CITY OF CODY
PLANNING, ZONING AND ADJUSTMENT BOARD
TUESDAY OCTOBER 26, 2021
CITY HALL COUNCIL CHAMBERS @ 12:00 NOON

CITY OF CODY PLANNING, ZONING AND ADJUSTMENT BOARD STAFF REPORT

MEETING DATE:	OCTOBER 26, 2021	TYPE OF ACTION NEEDED	
AGENDA ITEM:		P&Z BOARD APPROVAL:	X
SUBJECT:	OFF SITE PARKING AGREEMENT FOR 2401 G AVENUE.	RECOMMENDATION TO COUNCIL:	
PREPARED BY:	TODD STOWELL, CITY PLANNER	DISCUSSION ONLY:

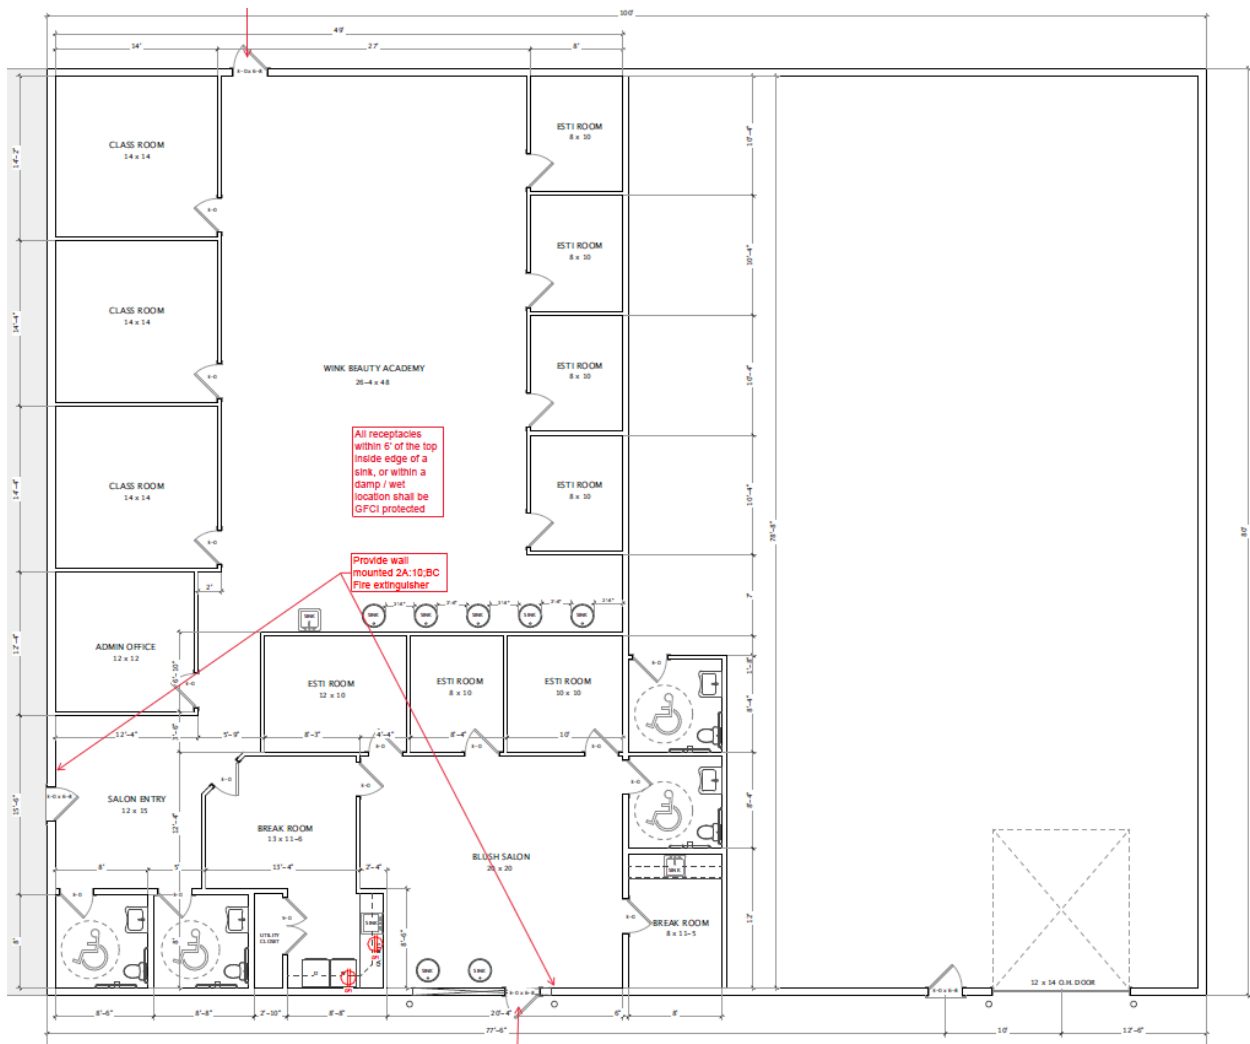
In response to staff's request for a parking plan, the above drawing was submitted, which shows a total of 25 spaces. Keeping the parking out of the sewer and utility easement, as specified in the agreement, would mean 105' is needed in the north-south dimension to provide the nine spaces shown in the east row.

In order for the proposed parking lot to meet applicable construction requirements, the following modifications are needed:

- 1) Add wheel stops to the spaces in the east row.

- 2) If the east parking lot will be used at night, add parking lot lighting (a full-cutoff style fixture, mounted on the wall of the building would work). The south parking lot already has a light.

1. Expand the lease area in the parking agreement from 100' to at least 105'.
2. Add wheel stops to the spaces in the east row (one stop per space, centered).
3. Surfacing and construction of the parking lot shall comply with the City standards.
4. If the east parking lot will be used at night, add parking lot lighting (a full-cutoff style fixture, mounted on the east wall of the building would work).
5. The executed parking agreement is to be authorized by the city attorney and recorded at the County clerk's office prior to occupancy of the beauty school/salon.

MAIN FLOOR

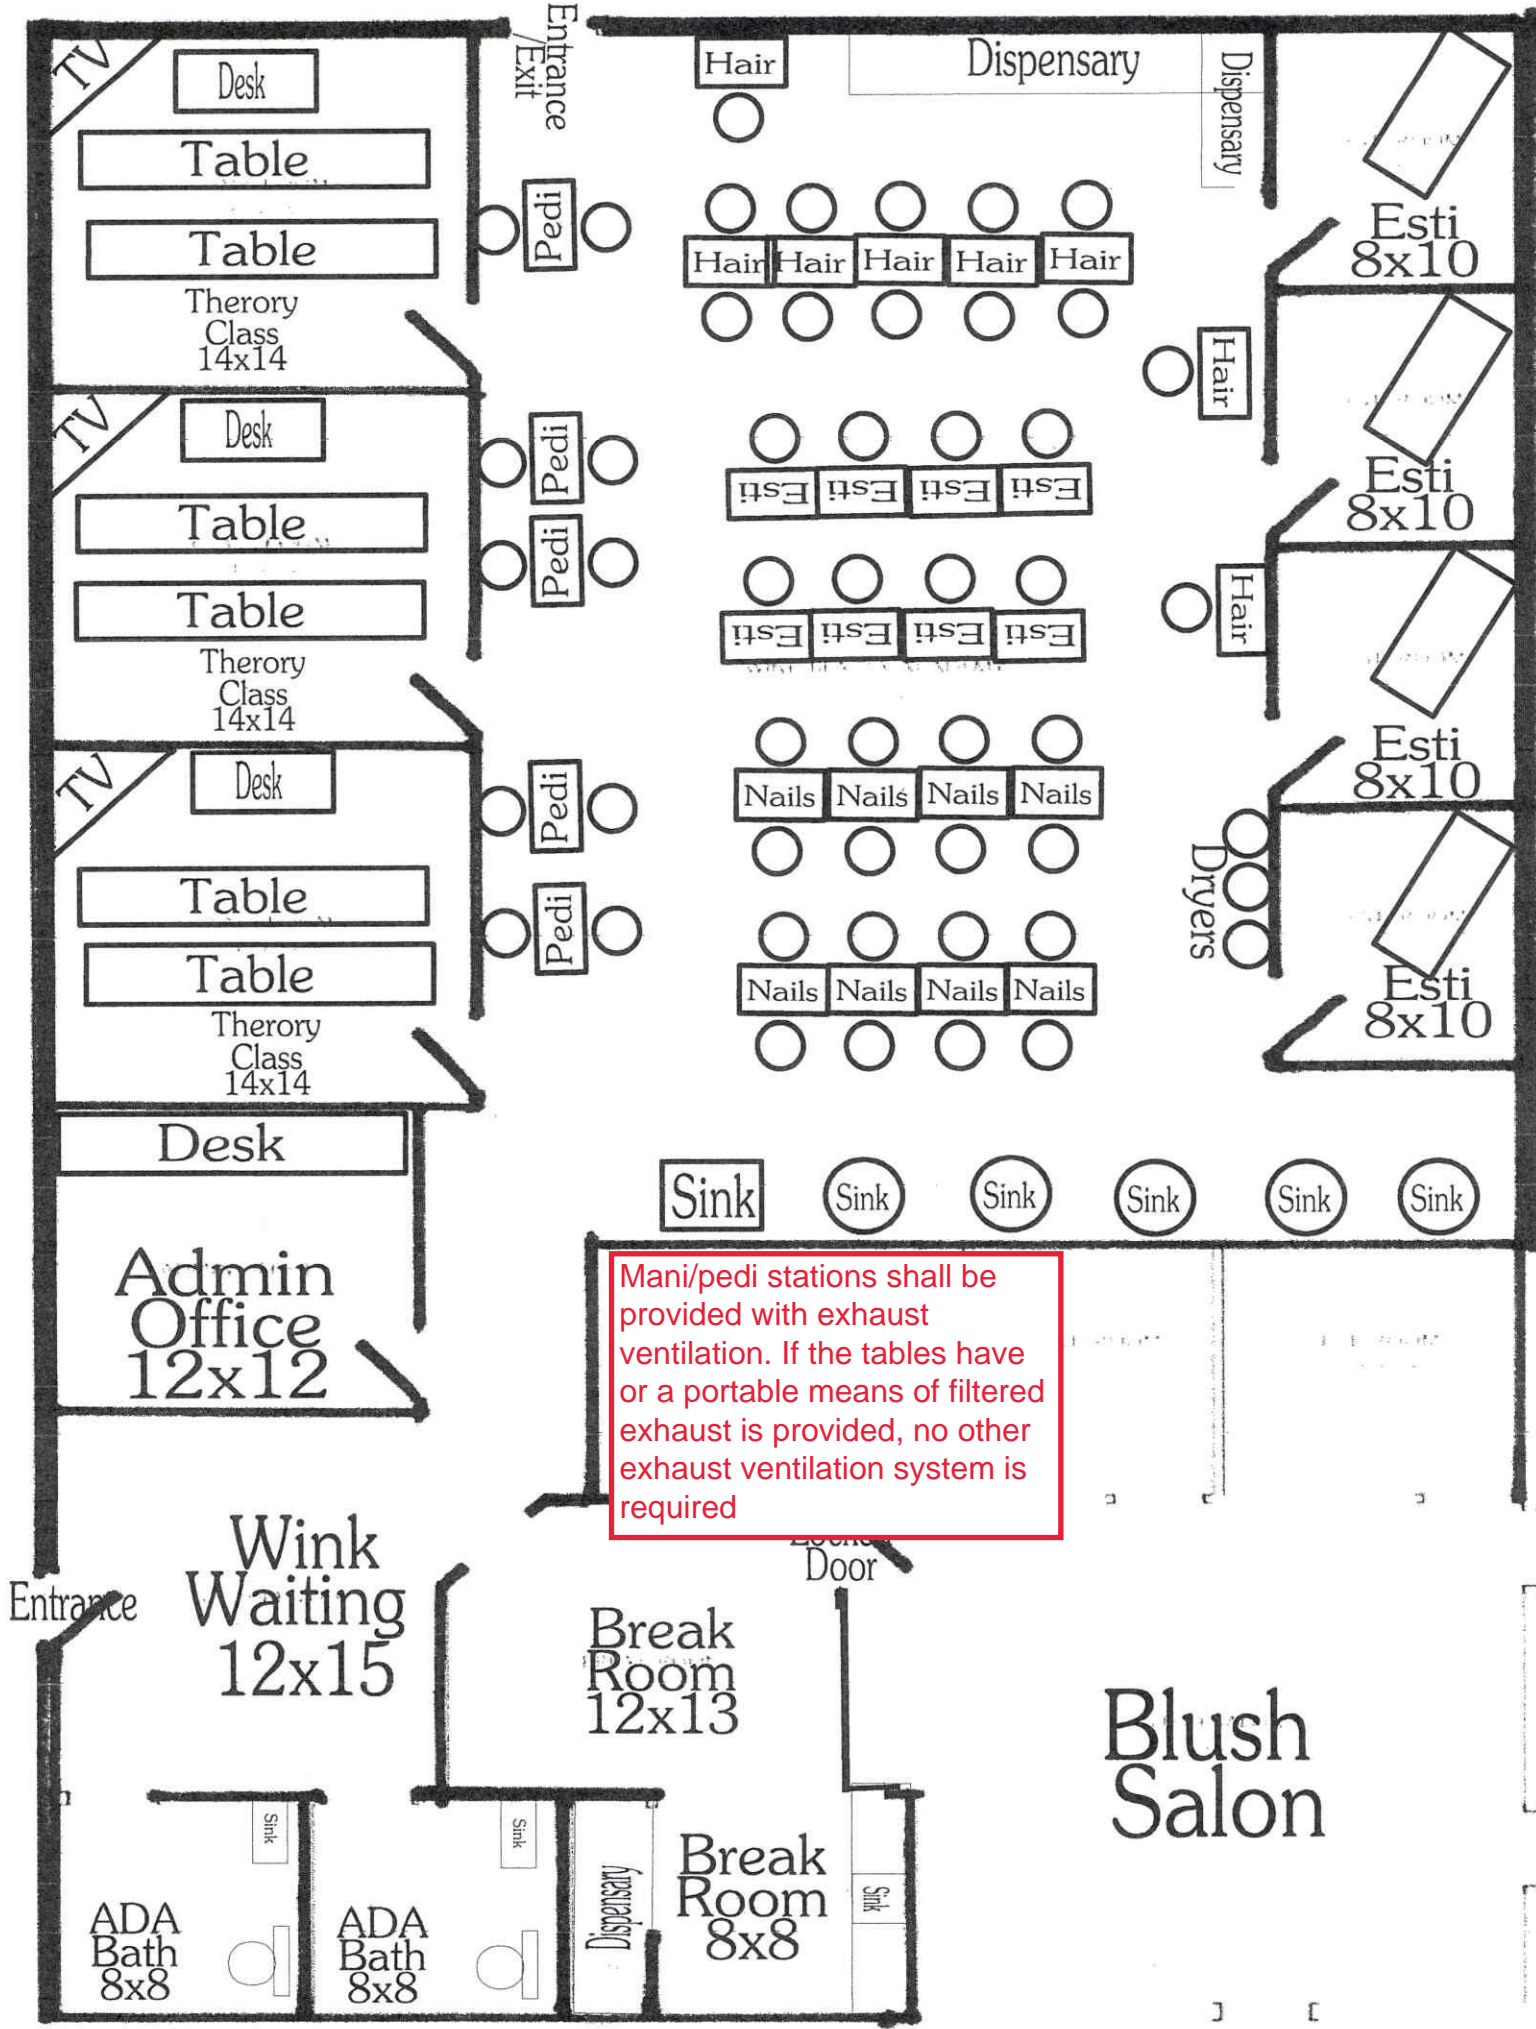
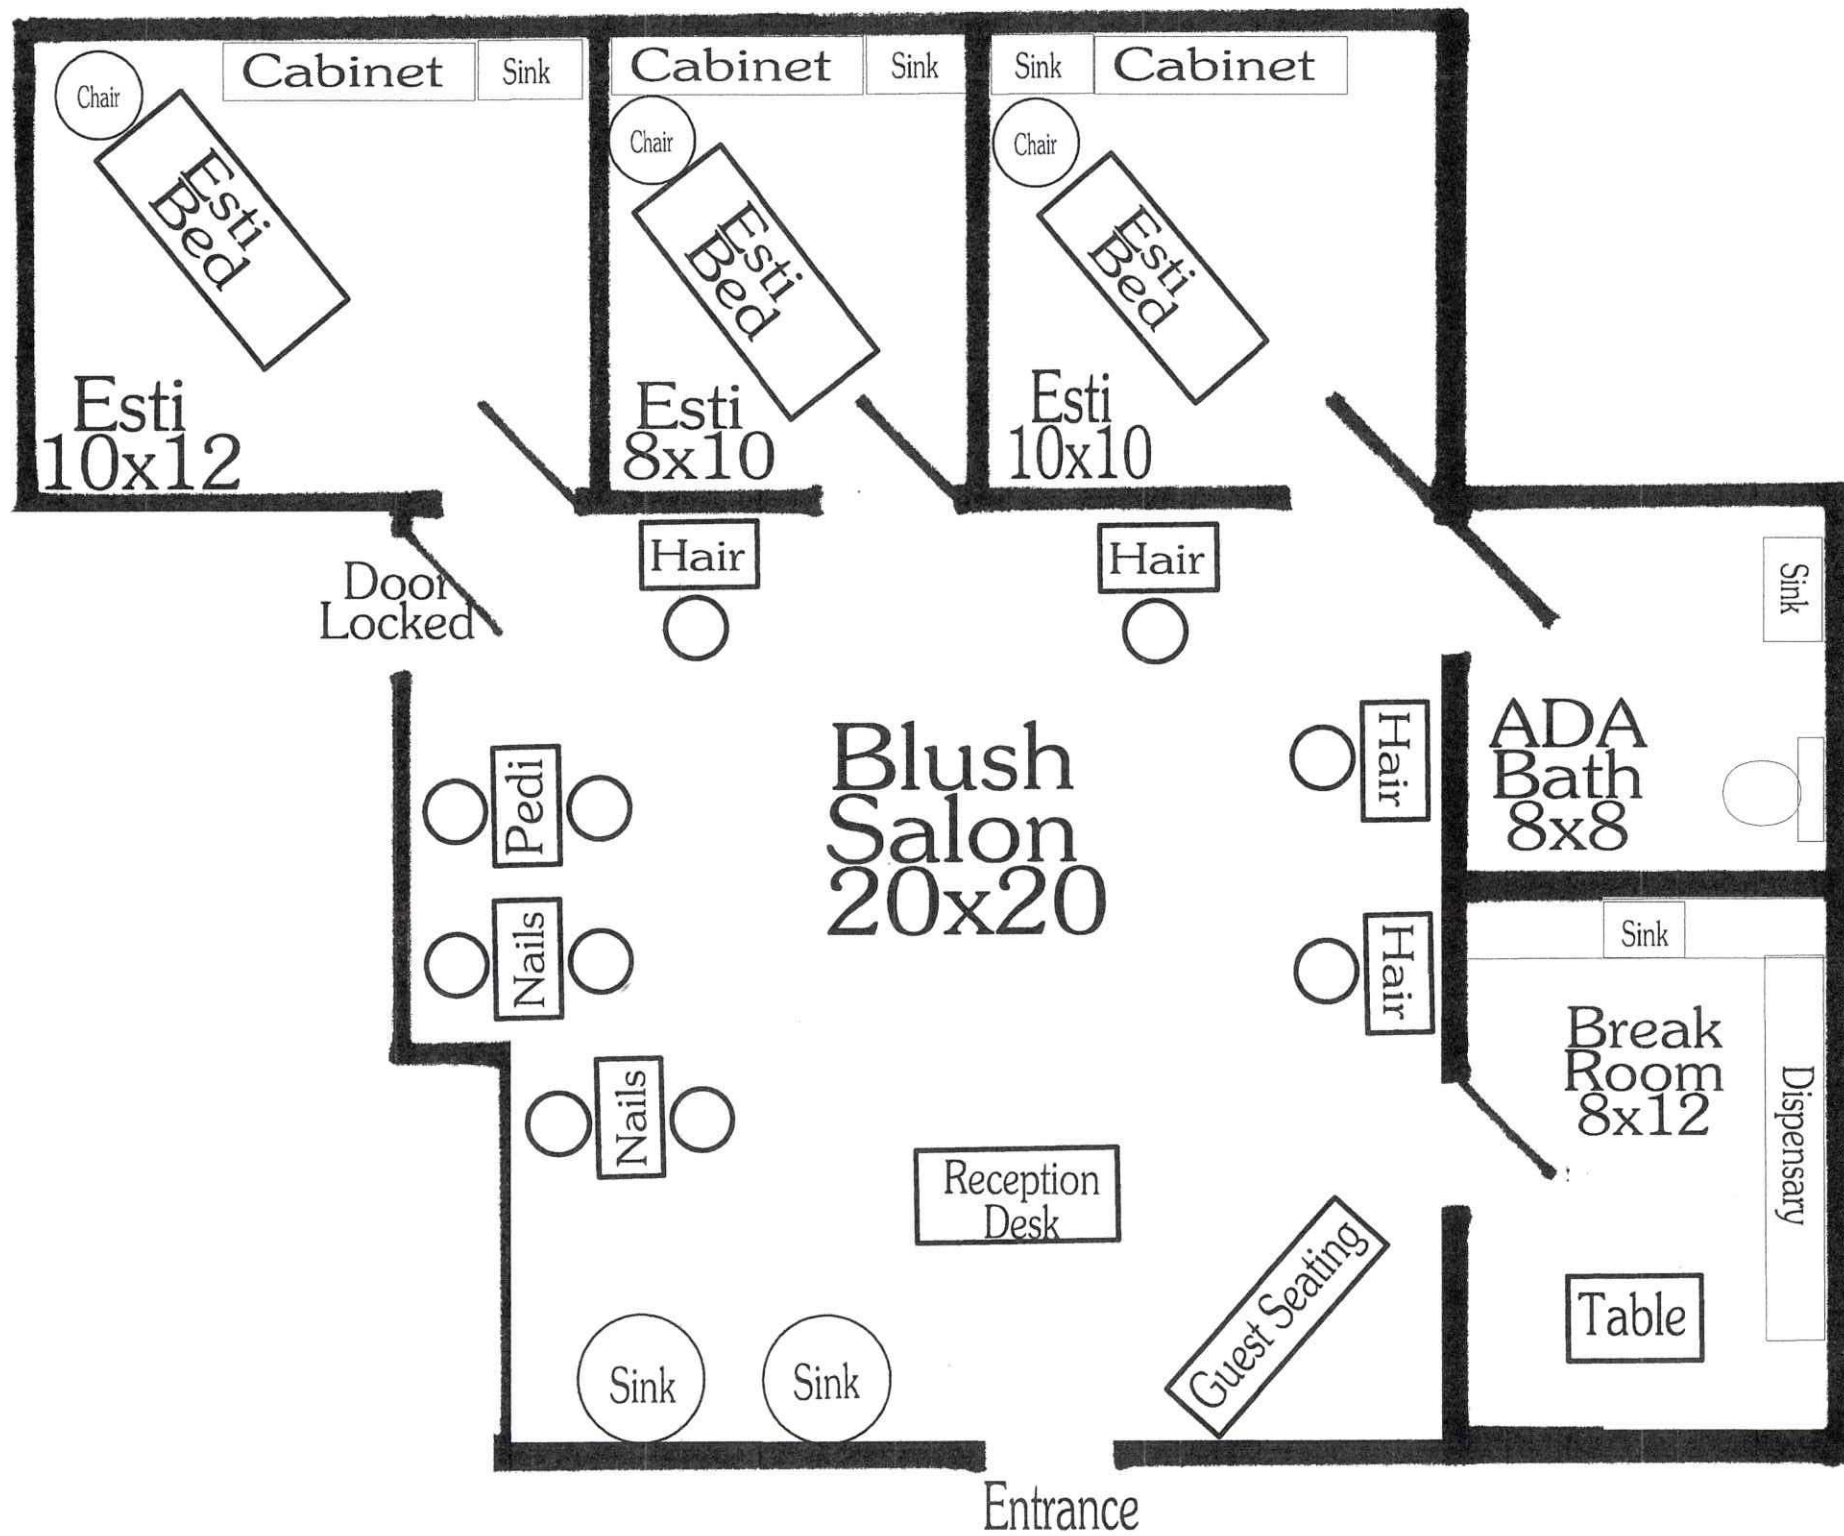
Mani/pedi stations shall be provided with exhaust ventilation. If the tables have or a portable means of filtered exhaust is provided, no other exhaust ventilation system is required

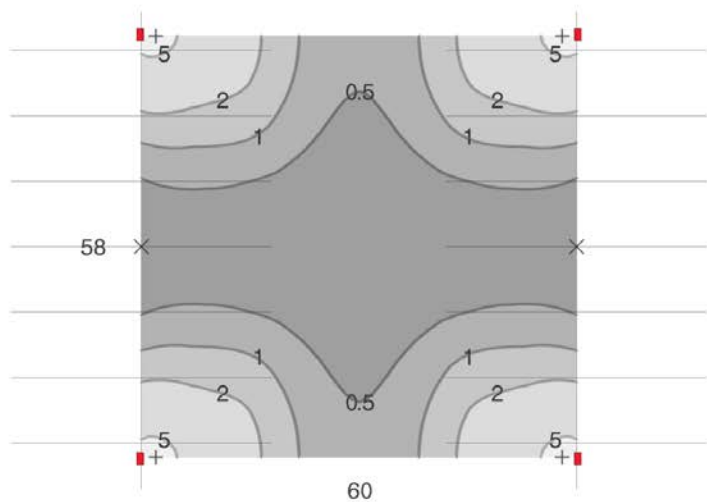
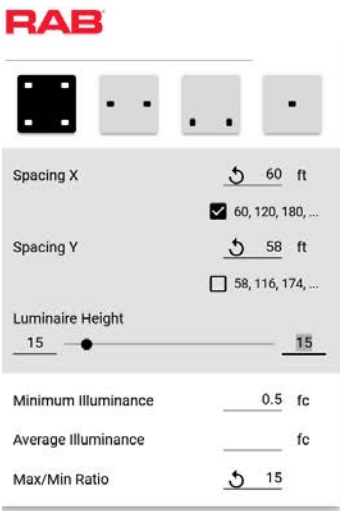
The application shows 26-watt LED, full cutoff style fixtures on the buildings, spaced at 45 feet on center on the sides of the building that face each other. The calculated result is shown on the first photometric map below. The proposed fixtures and spacing will provide an amount of light that is recommended by many lighting publications for a standard parking lot. (Lighting for Parking Facilities RP-20-98 (IESNA 1998) recommends a maintained horizontal illuminance level of 0.2 footcandles for "basic" parking lot lighting. Average levels recommend for parking lots are 2.0 to 0.5 fc in most publications.)

The style of fixture selected is typically what the Board has historically approved. However, in the past, the Board as questioned whether storage facilities really need

that level of lighting. If that is still their position, planning staff would recommend that either the wattage be reduced and/or the spacing be increased. The information below is provided as a comparison to the wattage and spacing proposed on the application, using 18-watt fixtures at a 60-foot spacing. A 12-watt version is also available.
